**Project site has increase approximately 1.25 acre to the East along Mission Ave frontage, with full landscaping**

**PR-2018-001355 SI-2018-00123**

Re: Minor Administrative Amendment to Site Plan Submittal  
Albuquerque Bernalillo County Water Utility Authority (ABCWUA)  
Customer Service and Operations Facility  
6000 Alexander Blvd NE

**Project #2018-001355**  
SI-2018-00123 – Major Amendment of Prior Approval, Site  
Development Plan

**H3 SITE PLAN EAST**  
1" = 40'-0"

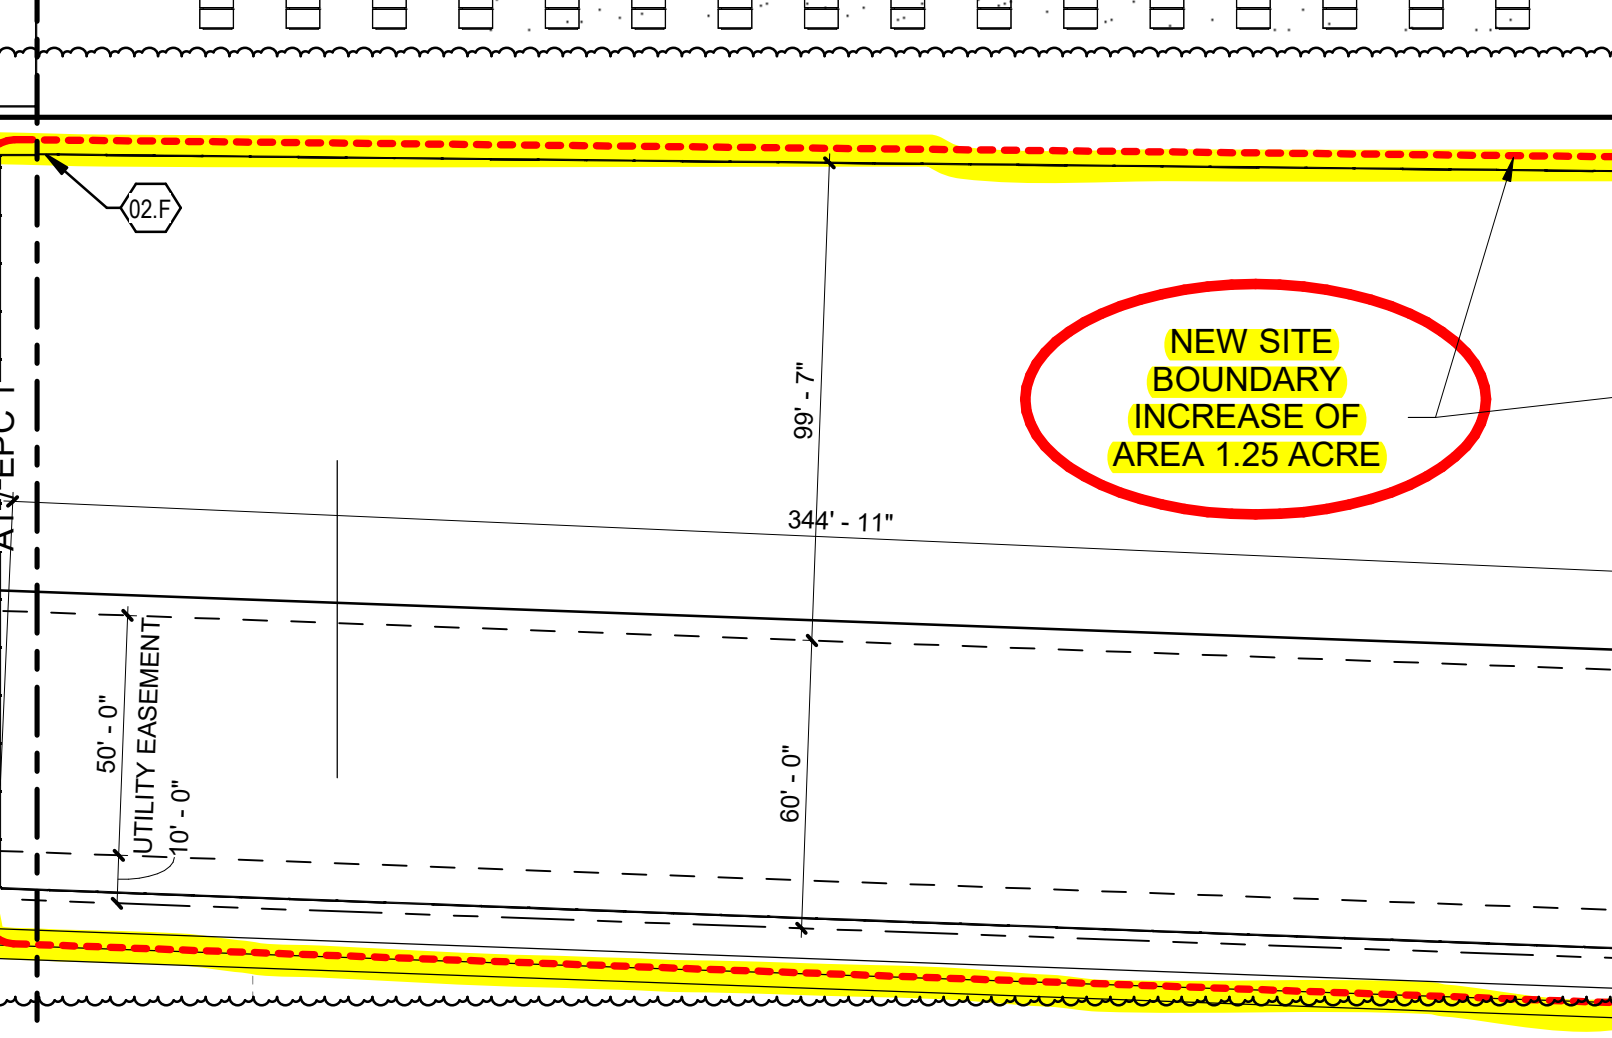
As agents for the ABCWUA we are submitting a Minor Amendment to Site Plan for administrative approval. This amendment is for additional project site area of approximately 1.25 acres to the East between Mission Ave. and the existing PV array. This additional area is needed as a source for construction earthwork fill material and to improve the property frontage with new landscaping.

45,375 SF. LANDSCAPE PARK WITH SCREENING
